Public Input No. 1-NFPA 58-2013 [Global Input]

NOTE: This public input originates from Tentative Interim Amendment 58-14-1 (TIA 1079) issued by the Standards Council on August 1, 2013 and per the NFPA Regs. needs to be reconsidered by the Technical Committee for the next edition of the Document.

Figure X.1 Typical container purging system.

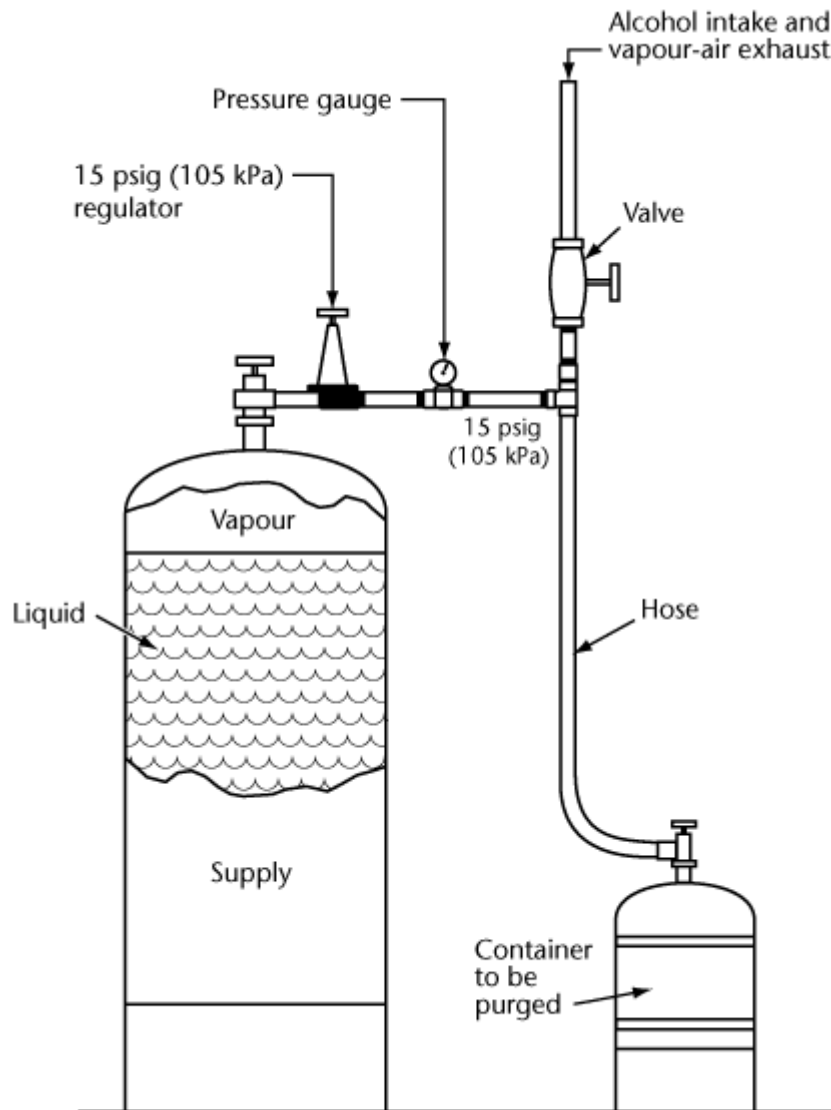
1. To remove air and moisture from a container being prepared for propane service using a purging assembly as shown in Figure A.1, complete the following steps:

Figure X.2 Mounting on unibody vehicles

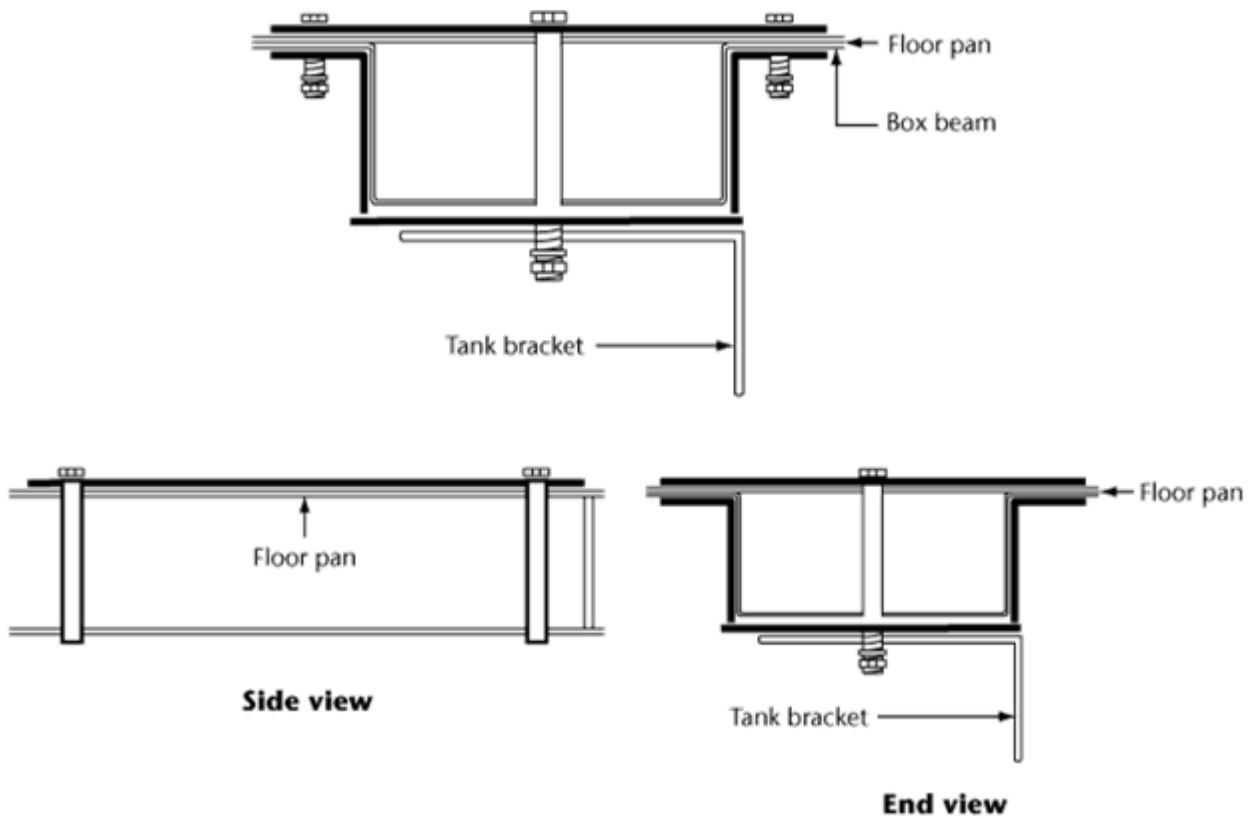
For the purpose of installing a *tank* on a unibody vehicle, a structural member of the vehicle shall not be cut in such a manner as to reduce the strength of the member to a level below the strength required for the purpose for which the member is intended. When drilling through a floor pan or frame member, adequate reinforcement shall be provided on the top, sides, and bottom of the *tank* mounting area (See Figure X.2). Existing holes shall be used wherever possible.

Wherever a hole is drilled or metal is reinforced, corrosion protection shall be provided.

Figure X.3 Propane tank located behind the rear axle

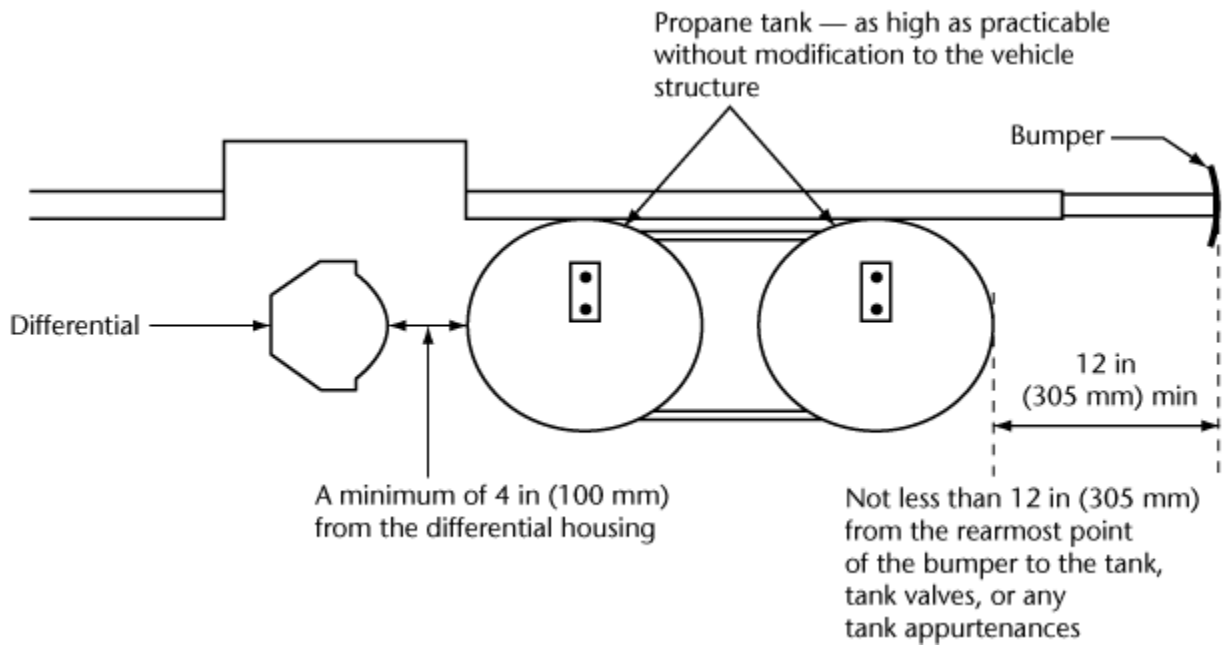
A rear-mounted *tank* is vulnerable to damage and shall be installed in an area where it will be less exposed to physical damage in the event of an impact (See Figure X.3)

Figure X.4 Bumper protection for a unibody bus

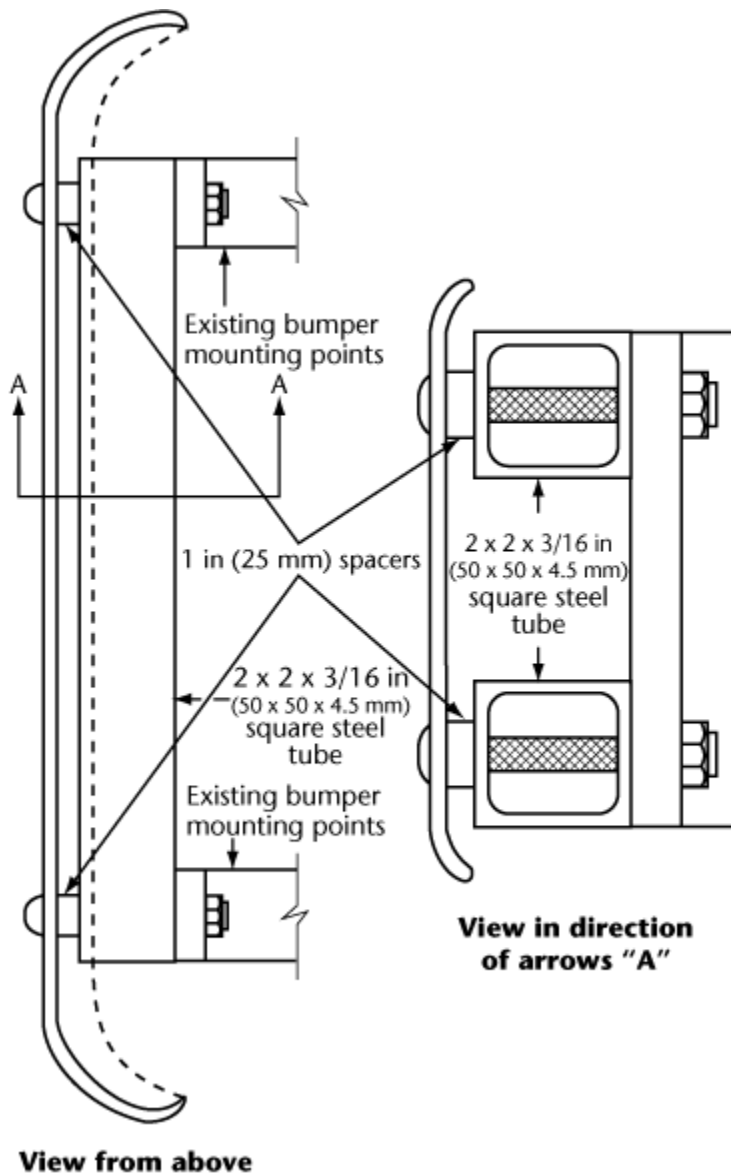
Reinforced bumpers enhance the safety of a rear-mounted *tank* in the event of a vehicular impact. The guidelines shown in Figure X.4 are intended for reinforcement of standard vehicle bumpers. Other means of protection may be used if designed in accordance with good engineering practice.
